Horizontal Well
API Pending
Hayhurst 16 25 27 State #2H
Chesapeake operating

Re: Application of Chesapeake Operating, Inc., agent for Chevron USA, Inc., for administrative approval of an unorthodox well location for its Hayhurst 16 25 27 State 2H well in the Bone Spring formation in Section 16, Township 25 South, Range 27 East, N.M.P.M., Eddy County, New Mexico.

**Chesapeake's NSL Application
Hayhurst 16 25 27 State 2H well**

WELL LOCATION AND ACREAGE DEDICATION PLAT

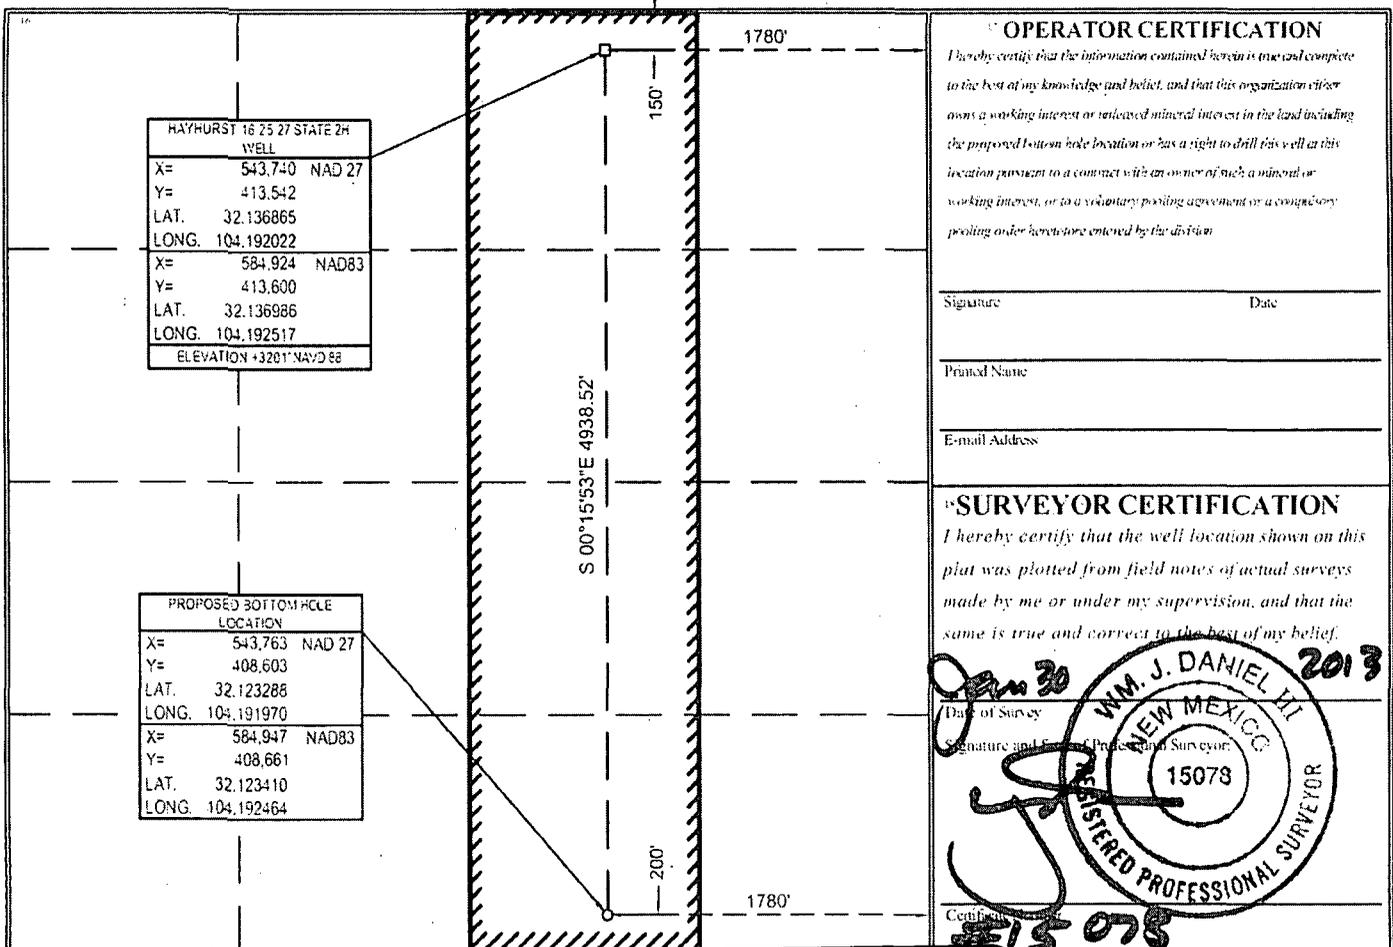
This NSL Application for a horizontal well seems to be premised on the assumption that the location is non-standard only at the bottom hole location, at the South end of this proposed North-to-South lateral. However, the surface location is non-standard at the North end of the project area, and I find no statement in your letter or the accompanying materials identifying the footage location of the beginning point of the completed interval.

Please advise us of the location of the beginning of the completed interval, so I can determine if this proposed location is non-standard to the North.

I will check with Chesapeake to confirm. Generally, their practice is to set the surface location 150 off the line and drill the curve so the first perfs are more than 330 off, but I recognize that in this C-102 and in my letter, it does not stat where the first perfs are to be located.

Do they need to file an amended C-102 or can they just take care of this issue when they file an as-drilled C-102?

No need to file an amended C-102 for the NSL application. Just get them to give you estimated footages for the first perforation, and send me that information.

The attached C-102 shows that the estimated first perms will be 330 off the section line and, thus, at a standard location for the 2H well.
